UNITED STATES PATENT AND TRADEMARK OFFICE

10/590,125

Andre Schlienger

Office Action Summary	Application No. 10/590,125	Applicant(s) SCHLIENGER ET AL.	
	Examiner STEVEN J. COTRONEO	Art Unit 3733

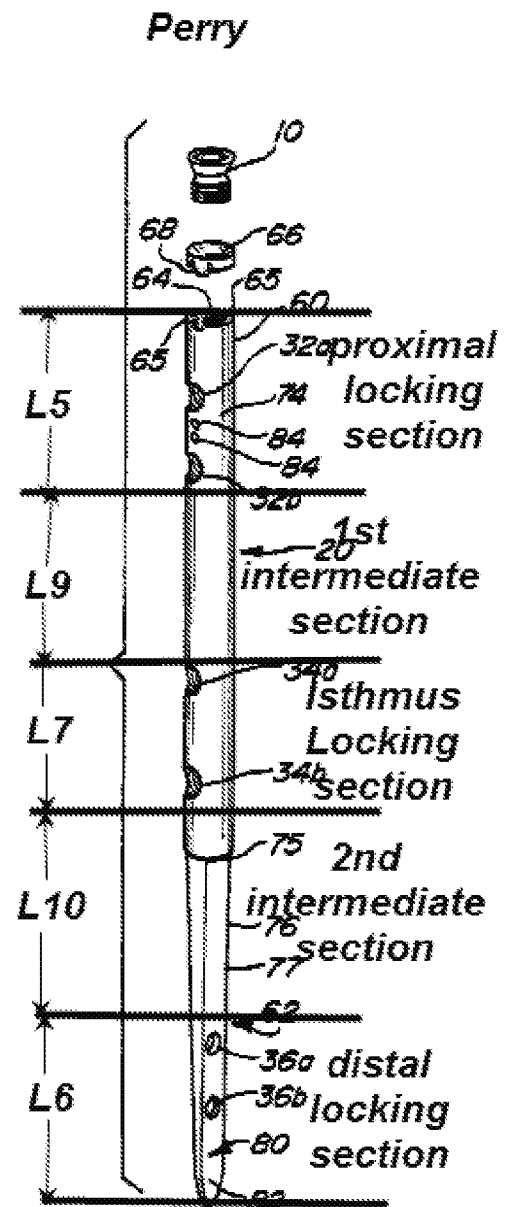
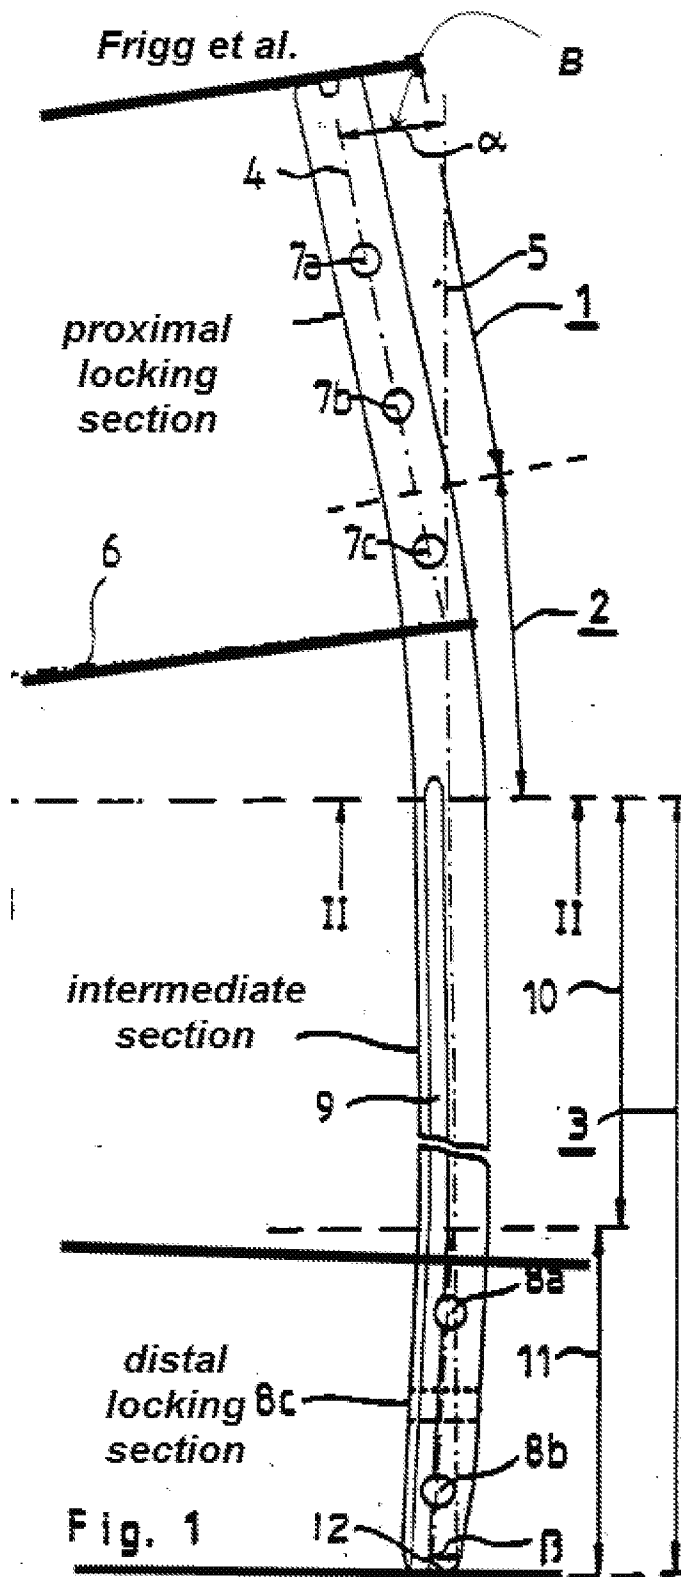
Perry discloses an intramedullary nail comprising: an elongated nail body having a proximal end, a distal end for insertion into the medullary canal, a central axis and a total length L; a proximal locking section (fig 4, 32), distal locking section (fig 4, 36), and isthmus locking section (fig 4,34) spaced along the length of the nail body, the proximal locking section nearest the proximal end, the distal locking section nearest the distal end, and the isthmus locking section located between the proximal and distal locking sections, and each locking section including a through- hole for receiving a locking screw; a first intermediate section (see fig 4 below) separating the proximal and isthmus locking sections, and a second intermediate section (see fig 4 below) separating the isthmus and distal locking sections, each intermediate sections having fewer through-

holes per unit length than the locking sections. The intermediate section has no through holes (fig 1).

Perry does not disclose wherein the proximal locking section forms an angle B with the intermediate section, where B is in the range of $7^{\circ} < B < 13^{\circ}$.

Frigg et al. a proximal locking section forms an angle B with the intermediate section (see fig 1 below), where B is in the range of $7^{\circ} < B < 13^{\circ}$ (col. 4 ll. 40-42, "8 to about 18 degrees") to allow for use in the tibia (abstract).

It would have been obvious at the time of the invention to one of ordinary skill in the art to modify the device of Perry with the proximal locking section forming an angle B with the intermediate section, where B is in the range of $7^{\circ} < B < 13^{\circ}$ in view of Frigg et al. in order to allow for use in the tibia.

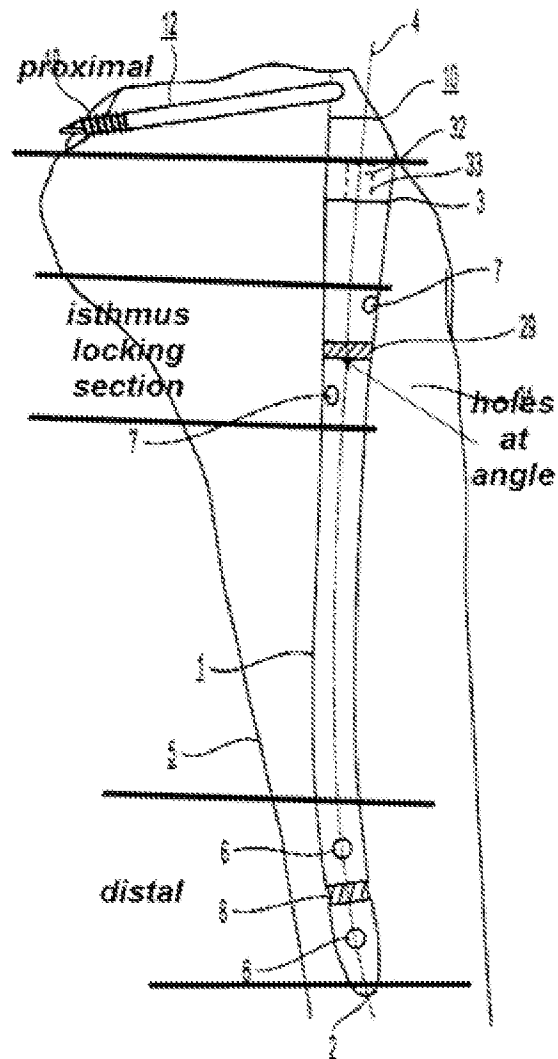
Perry in view of Frigg et al. discloses the claimed invention except for the isthmus locking section includes two through holes arranged at a relative angle A in the range of $60^{\circ} \sim 120^{\circ}$.

Leu et al. discloses the isthmus locking section includes two through holes arranged at a relative angle A in the range of $60^{\circ} \sim 120^{\circ}$ (see fig 1 below) to allow accurate positioning of the intramedullary nail in the intramedullary space.

It would have been obvious at the time of the invention to one of ordinary skill in the art to modify the device of Perry in view of Frigg et al. with the isthmus locking section includes two through holes arranged at a relative angle θ_t in the range of $60^{\circ} \sim$

120° in view of Leu et al. in order to allow accurate positioning of the intramedullary nail in the intramedullary space.
